clarifications on LDPC

Gaobo (Huawei)
Duane Remein (Huawei)

Size reduced LDPC

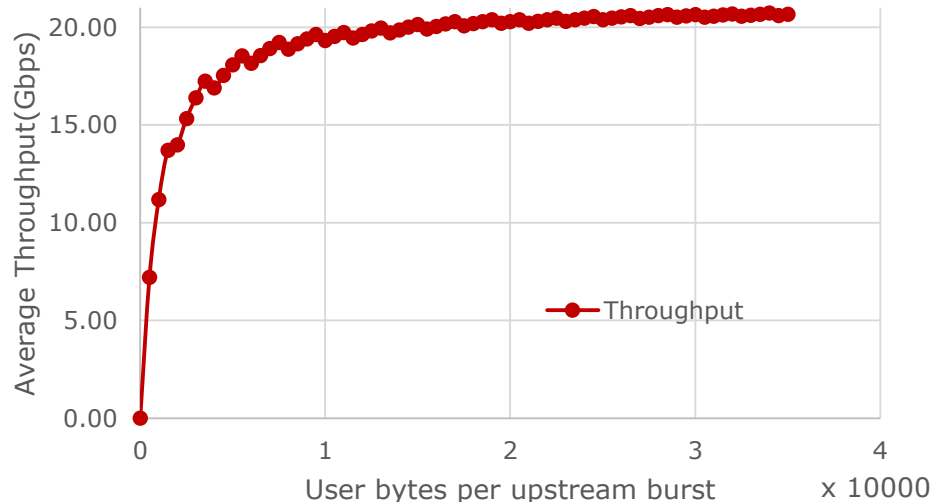
LDPC with shortening and puncturing still meet the performance objective

- Code rate is still 0.848 with 451bits shortened and 512bits punctured

20Gb/s achieved at least 17300 bytes burst size
